UNITED STATES PATENT AND TRADEMARK OFFICE

Office Action Summary

10/617,018

CHEN

Figure 4

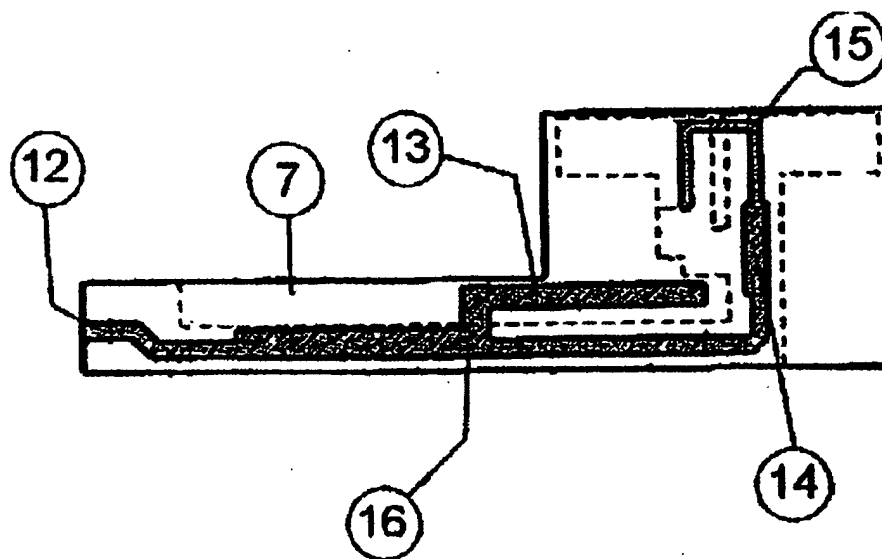
7. Claims 1 and 3 are rejected under 35 U.S.C. 102(e) as being clearly anticipated by **Petropolous**.

Petropolous discloses a hidden planar antenna module (figure 4) for a mobile phone (Paragraph 22), said module is provided with a base plate having a predetermined area (figure 4), said base plate has on a surface thereof a first micro-strip section (#14) and a second micro-strip section (#13) being in relation with wavelengths of corresponding operation frequencies; the front ends of said micro-strip sections make an open circuit, the tailing ends of said micro-strip sections are connected to be used as a third micro-strip section of a feed line (#16); said second micro-strip section (#13) connected with said tailing end of said first micro-strip section forms an open stub for adjusting frequency width and impedance matching; said module is characterized by that: said feed line is connected with micro-strips of a related circuit (#12) and a grounding line to form said antenna module with a coplanar wave guide effect.
